Access Compliance Report Public Rights-of-Way (Curb Ramps)

Main Street: DEL_REY_DR Cross Street: IRVINE_BLV Location: SE

ADA ID: RPRK211014144117 Ramp Type: Type 4 - Parallel Initial Pass/Fail: Fail Overall Compliance: No Severity Score: 2

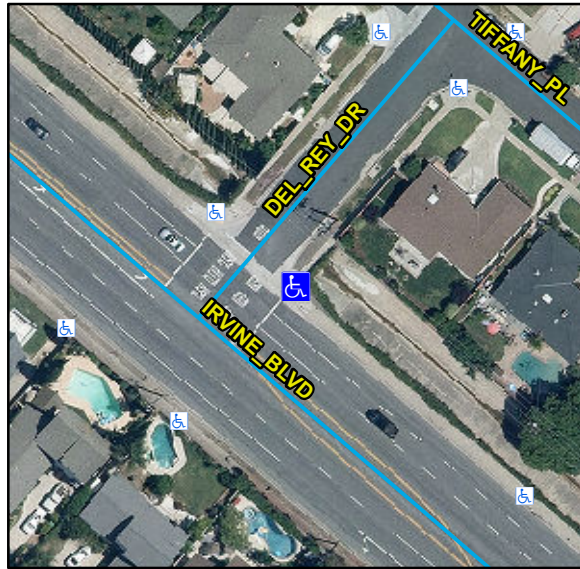
Compliance	Description	Data	Compliance	Description	Data
N/A	Ramp Length LT (in)	90	N/A	Ramp Length RT (in)	72
Yes	Ramp Width LT (in)	86	Yes	Ramp Width RT (in)	81
Yes	Ramp Run Slope LT (%)	6.7	Yes	Ramp Run Slope RT (%)	8.3
No	Ramp Cross Slope LT (%)	2.2	Yes	Ramp Cross Slope RT (%)	0.8
N/A	Landing Present	N/A	N/A	DWS Provided	N/A
N/A	Landing Length (in)	N/A	N/A	DWS Contrast	N/A
N/A	Landing Width (in)	N/A	N/A	DWS Length (in)	N/A
N/A	Landing Run Slope (%)	N/A	N/A	DWS Full Width	N/A
N/A	Landing Cross Slope (%)	N/A		DWS Offset Type	N/A
N/A	Landing Movement Obstructed?	N/A	N/A	DWS Offset Left (in)	N/A
	Landing Movement Type	N/A	N/A	DWS Offset Right (in)	N/A
N/A	Landing Shared	N/A			
N/A	Clear Space	Yes			
N/A	Clear Space To Crosswalk (in)	N/A			
N/A	Marked Crosswalk 1	No	N/A	Marked Crosswalk 2	No
	Crossing 1 Direction	NW		Crossing 2 Direction	W
	Marked Crosswalk 1 Width (in)	N/A		Marked Crosswalk 2 Width (in)	N/A

Remove & Replace Curb Ramp With Two New Directional Ramps or Equivalent.

R304.5.3, STD 1115
